TRANSMITTAL COVER SHEET

DATE: 21 June, 2024
TO: ALL PLAN HOLDERS OF RECORD
FROM: HUNTER SWATEK, AIA, PROJECT MANAGER
PROJECT: RAINBOW CITY RECREATION CENTER
GMC PROJECT NO. ABHM230021
RE: ADDENDUM NO. 3 AND
ACKNOWLEDGEMENT OF RECEIPT OF ADDENDUM NO. 3

ADDENDUM NUMBER 03

**PROJECT: RAINBOW CITY RECREATION CENTER
GM&C PROJECT NO. ABHM230021**

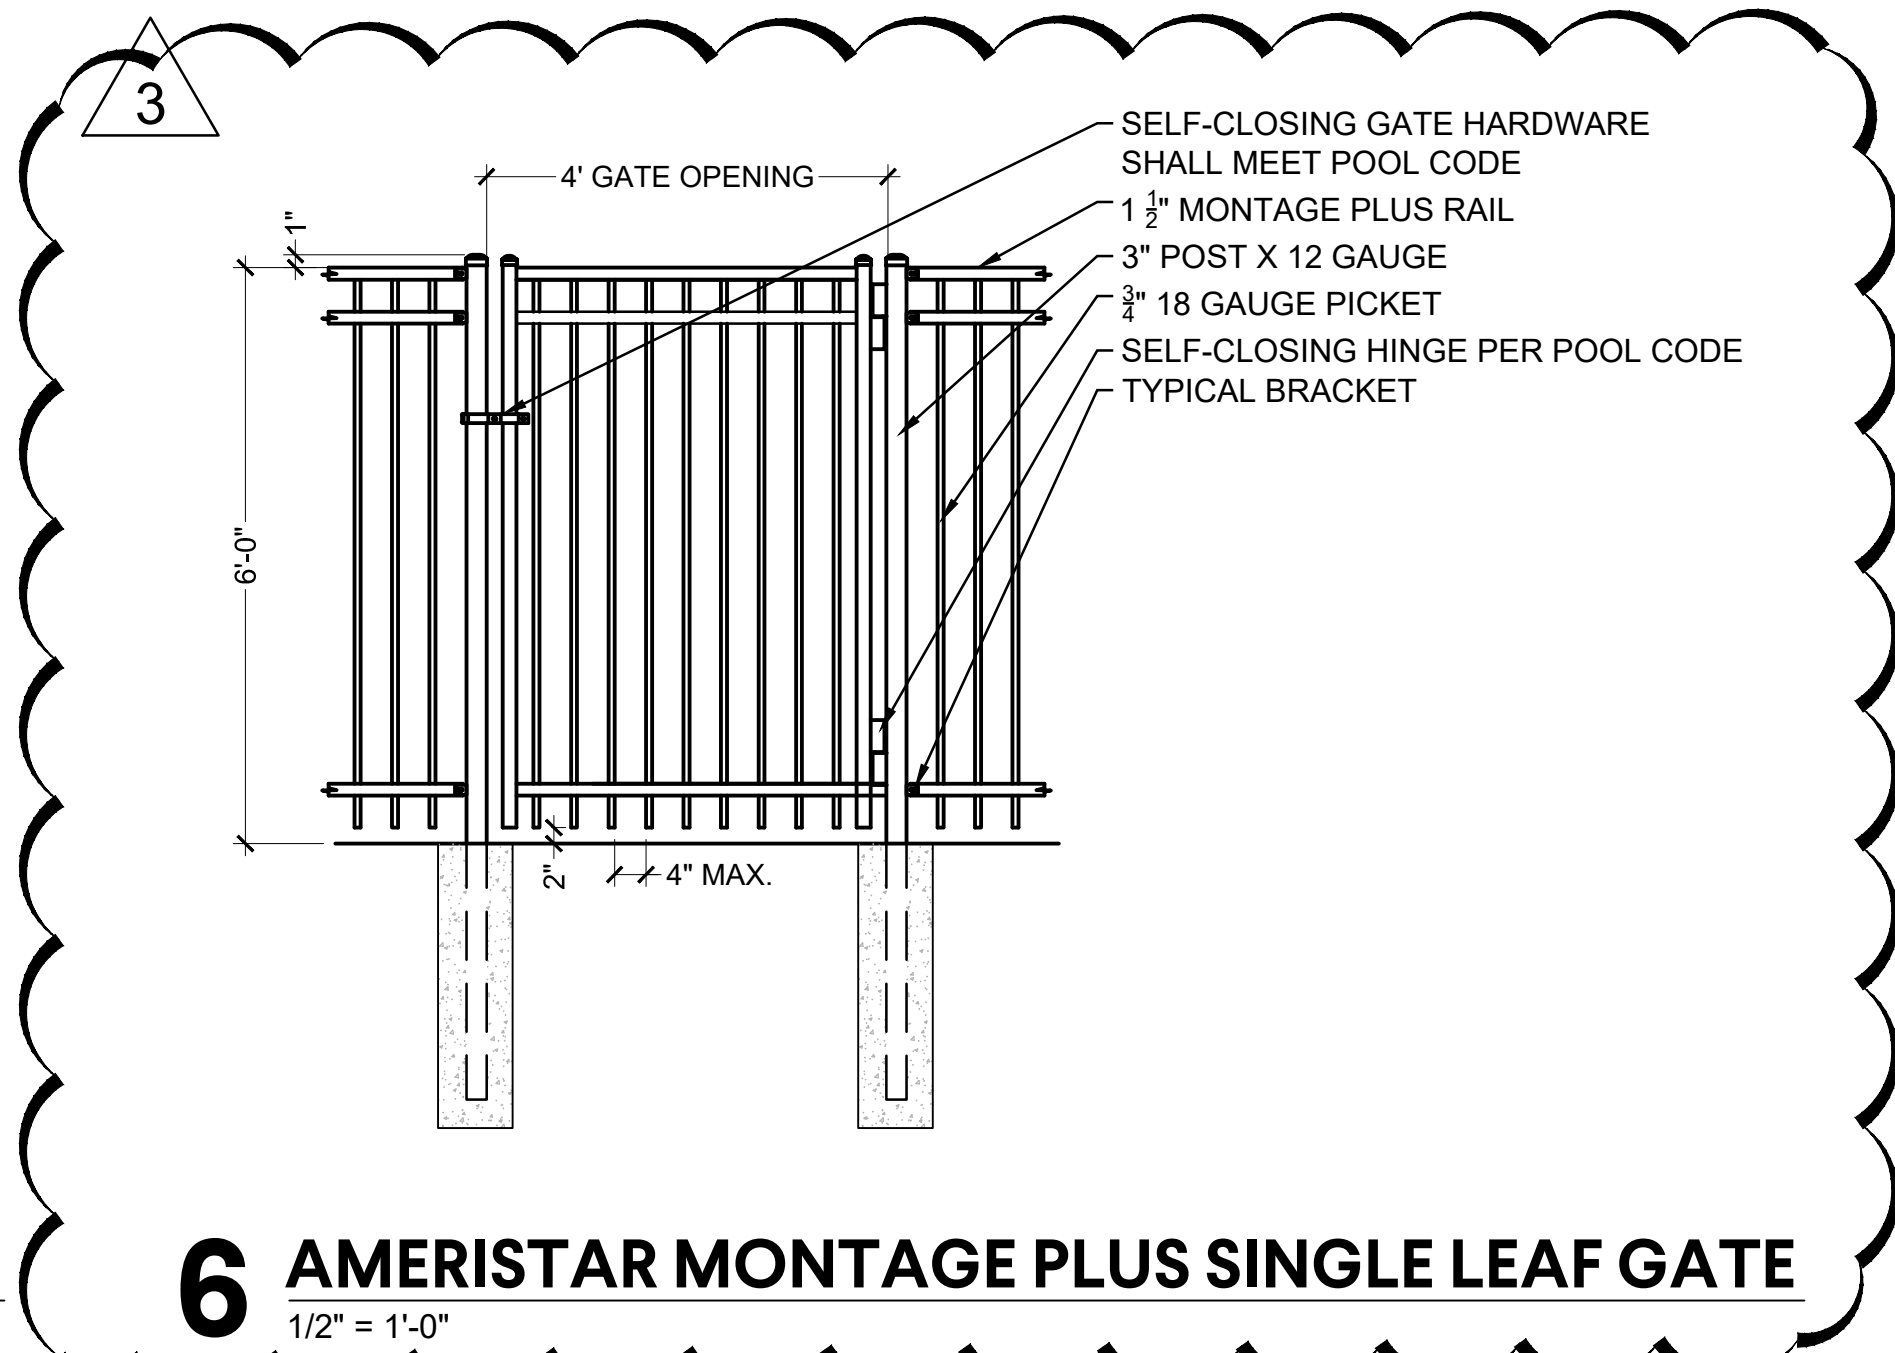
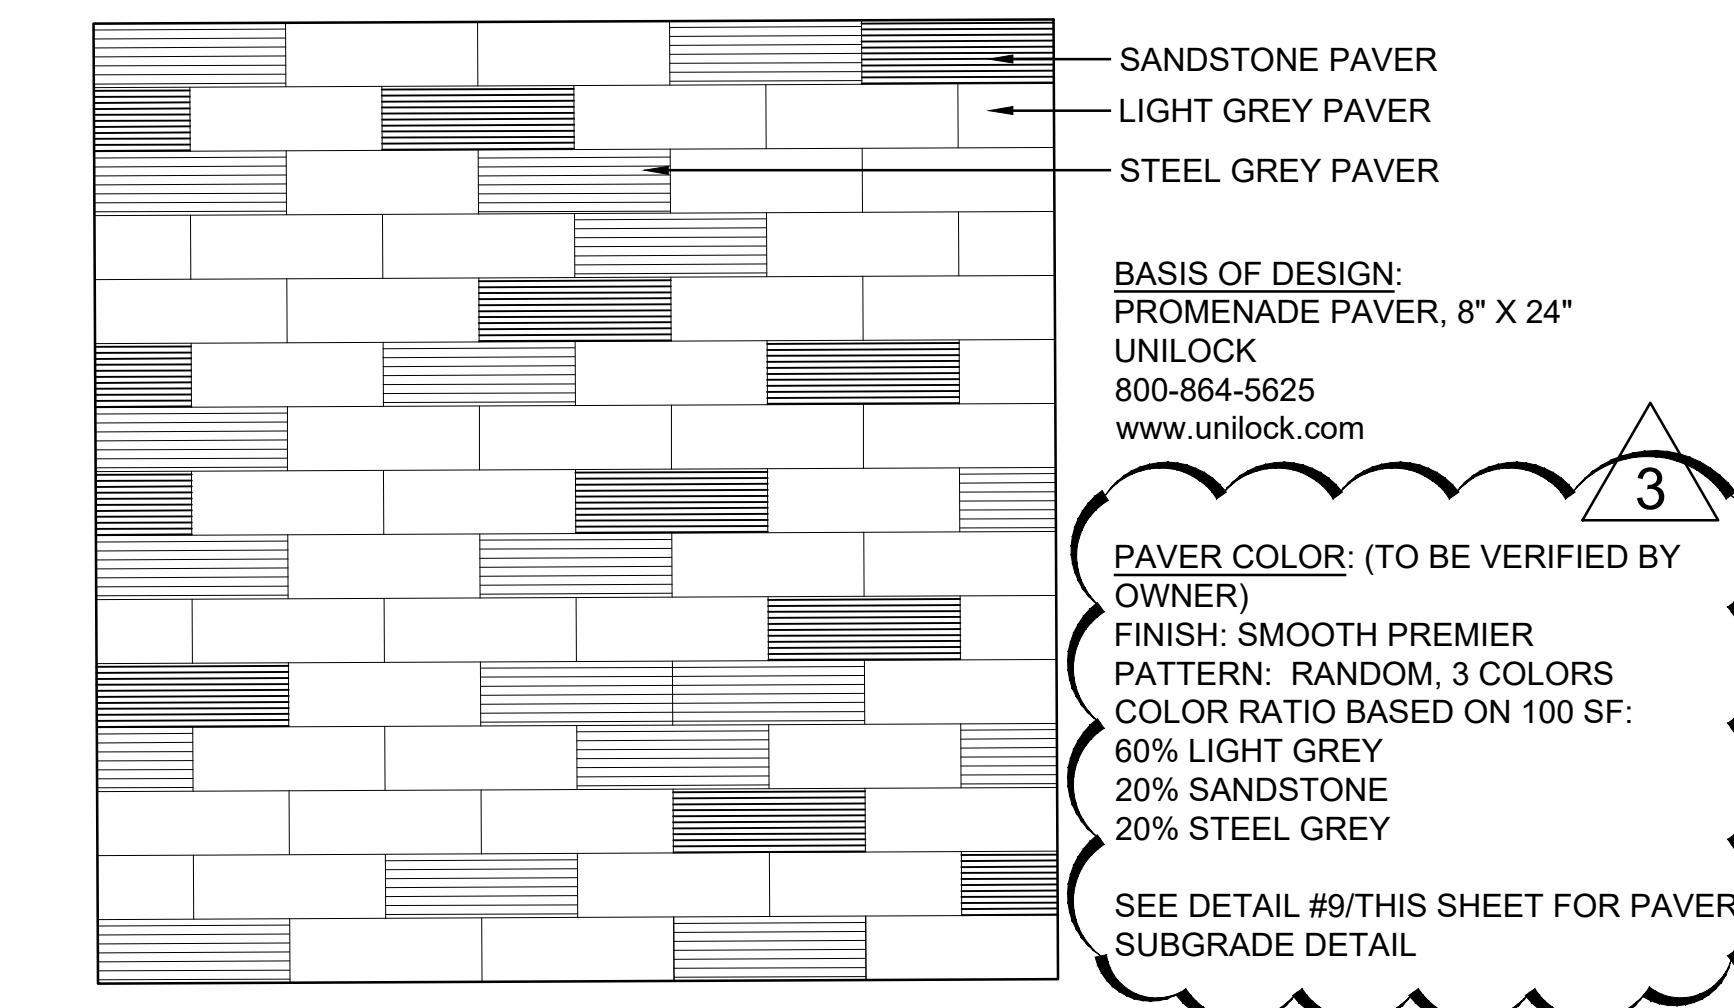
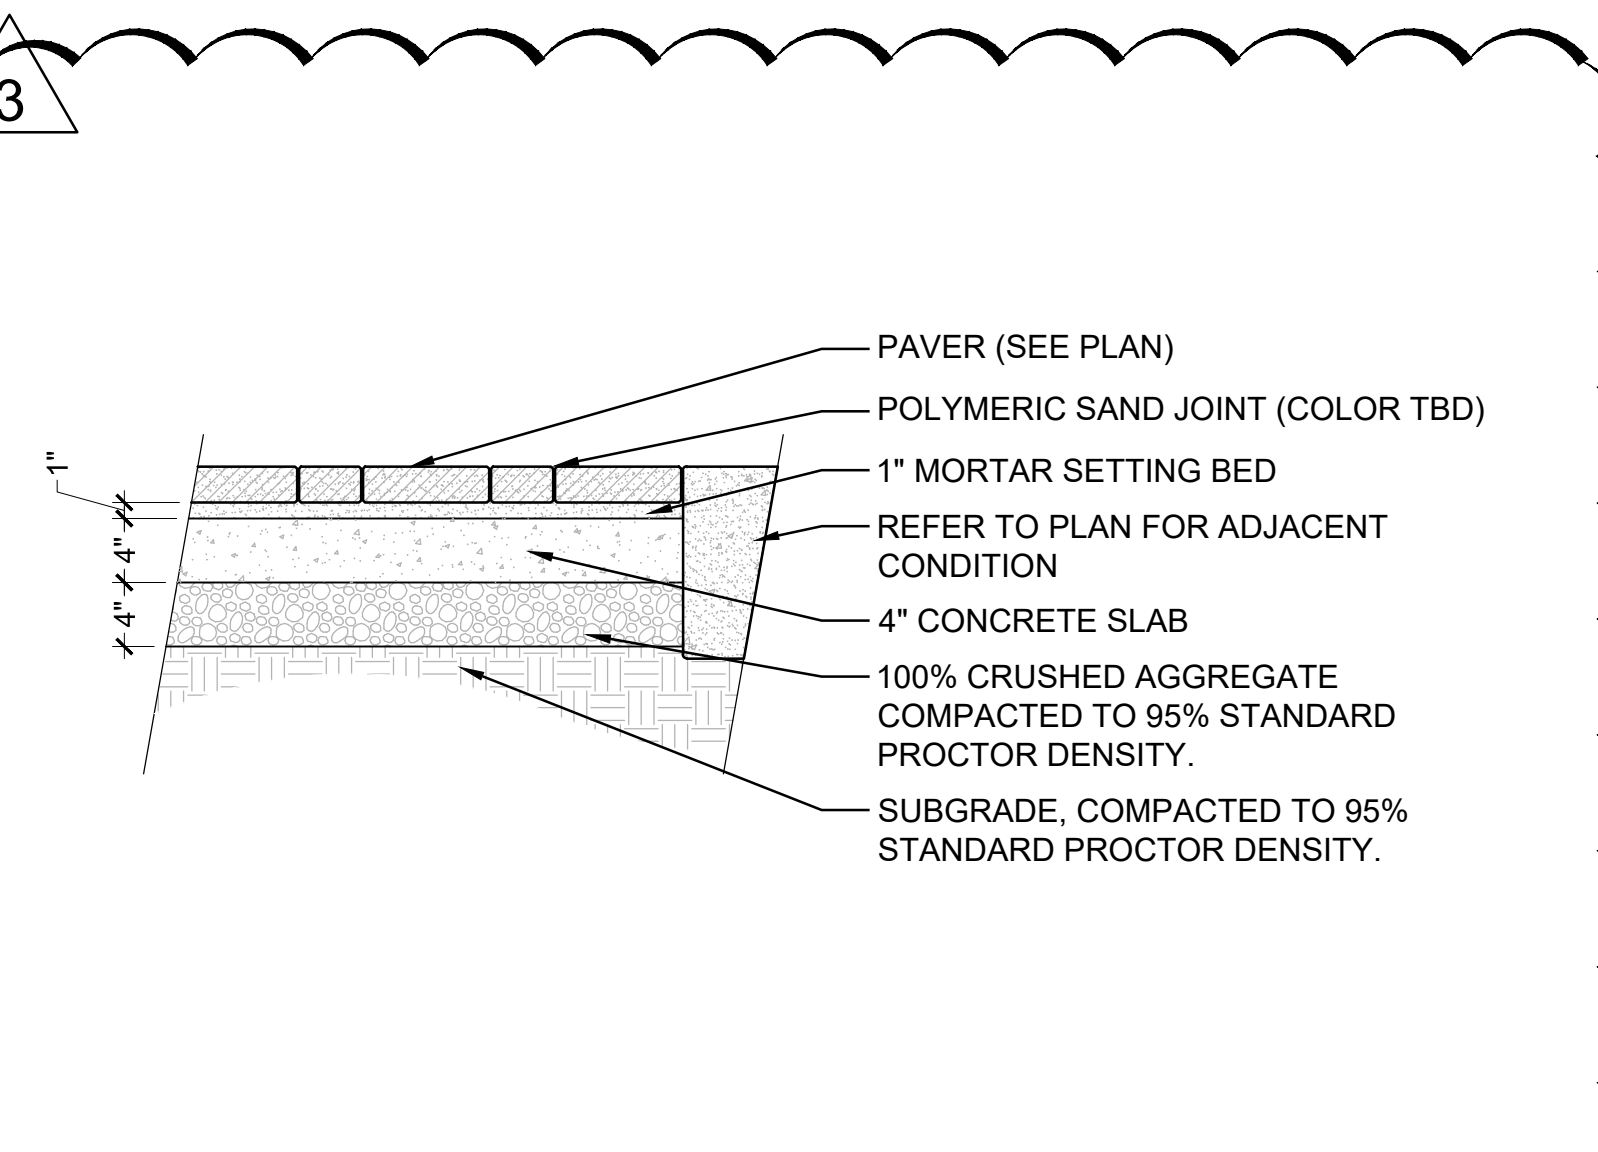
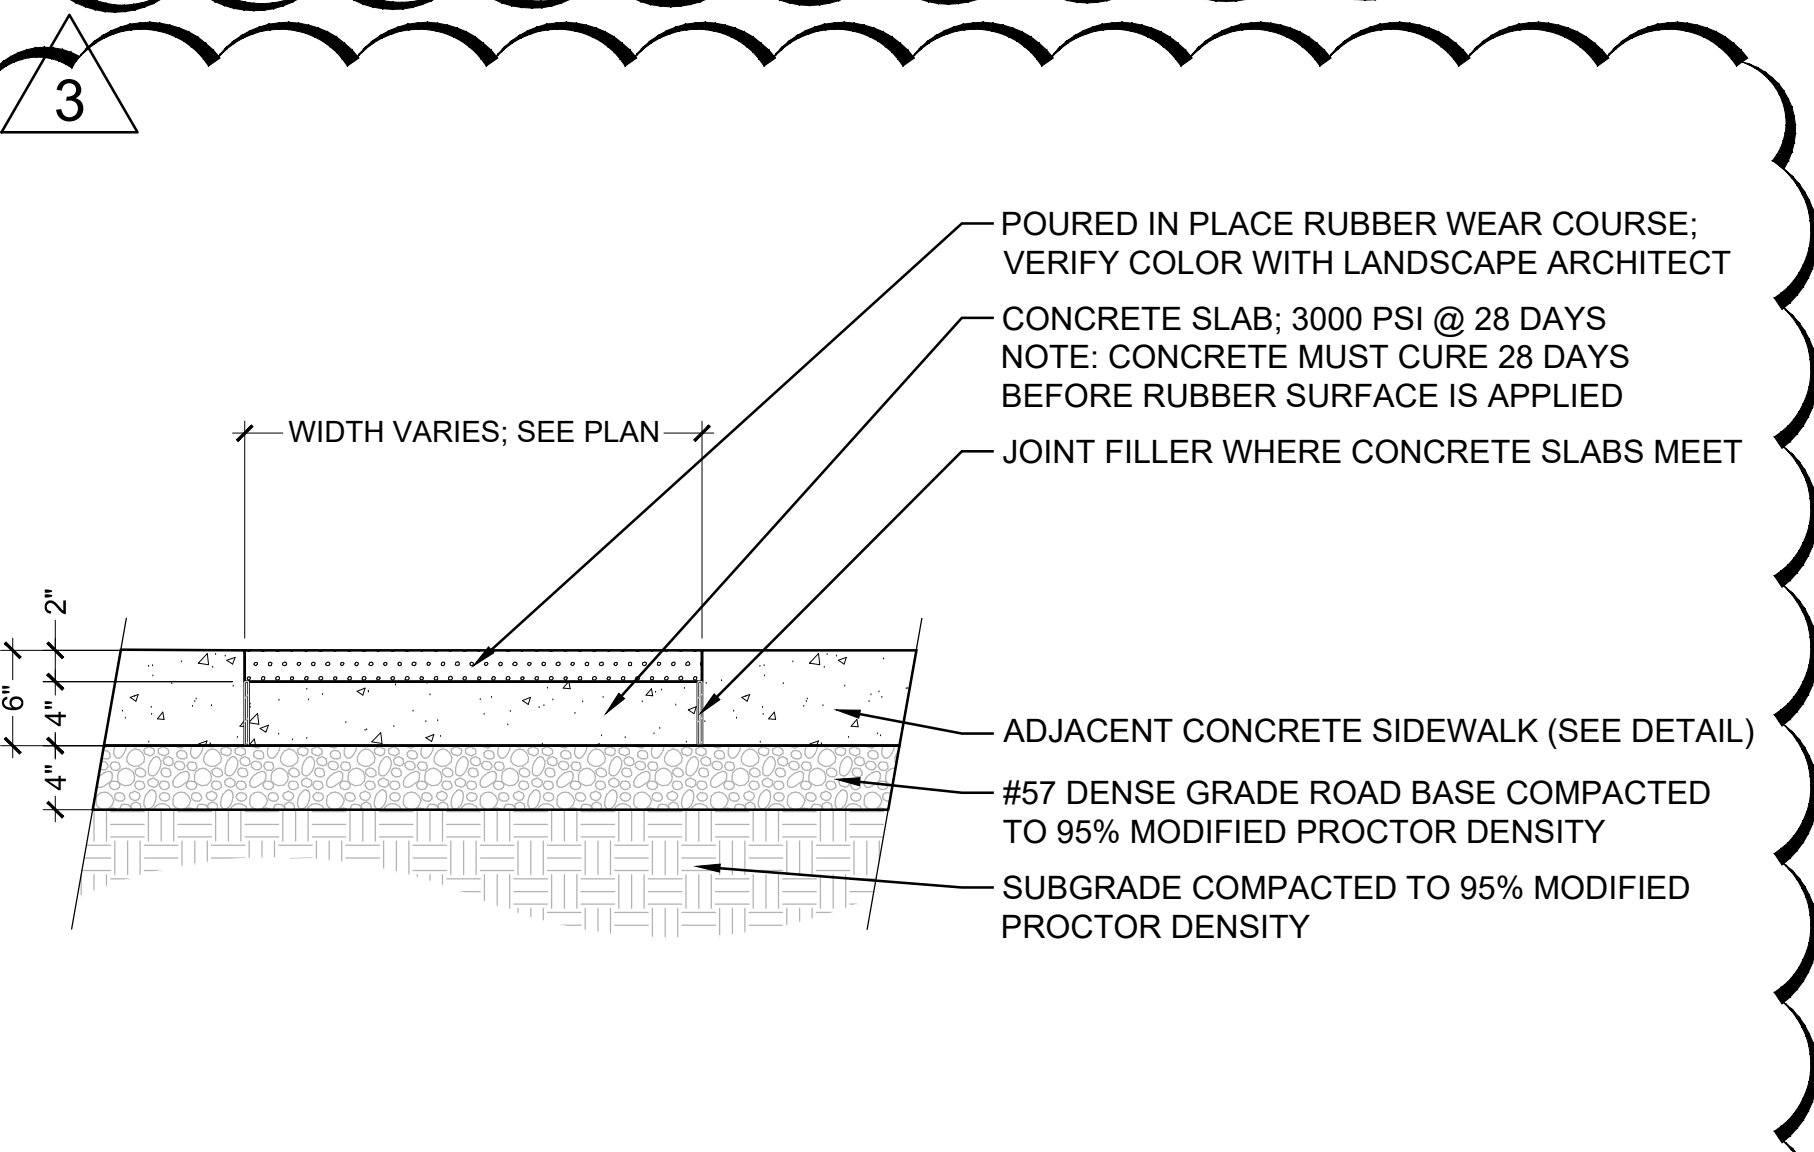
- O. **L1.01** – Materials Plan: Base
 - a. REVISED Notes
- P. **L1.02** – Materials Plan: Alternate
 - a. REVISED Notes
- Q. **L4.01** – Hardscape Details

- a. ADDED Details
- R. **S1.01** – Joist Loading Diagrams
 - a. REVISED Loads
- S. **S1.08** – Joist Loading Diagrams
 - a. REVISED Loads
- T. **S2.01** – Floor and Foundation Plan

5	Per the prebid, clarify that although the project is tax exempt, bidders are to include an occupational tax of 2%	1	Yes
6	Please provide the total R value of the roof insulation	1	Provide minimum R-25 c.i
7	There seems to be some discrepancy in the intent of alternates 2 and 3 between the Alternates spec, the Bid Form / Tax Form, and the drawings. Are these supposed to be additive alternates or deductive alternates? Please provide more info and clarification on these alts	3	See revised Alternates section and Civil drawings
8	Sheet L1.01 references Arch dwgs for outdoor showers, but cannot seem to locate on arch drawings. Provide spec/detail if to be included by GC in base bid or alt 2	3	Outdoor showers will be included in base bid. Shower location can be found on updated sheet L1.01. Refer to Addendum 02 Plumbing for piping information.
9	Provide detail for seat walls shown at brick paver areas and amphitheater area	3	See attached - L4.01

10	Provide subslab / subgrade prep requirements for brick pavers	3	See attached - L4.01
11	Provide spec for WDP-1 Parklex Wood Paneling	3	See Attached - Addendum 03

23	Is the WDF-1 condition the same as spec section 096466 Wood Athletic Flooring Assemblies? WDF-1 is not included in Finish Legend.	2	WDF - 1 is meant to be WFS - 1, WFS - 1 is referenced in the finish legend
24	On signage type details on A8.51, it shows types A1, A8, & A10. However, there are none of these shown on signage schedule on A8.52. Please clarify if these are included & their quantities & locations.	2	Correct, A1, A8, and A10 are not included in the project
25	Please provide details for the stairs for the amphitheater. Either the landscape or civil plans provide details for the stairs.	3	See attached - L4.01
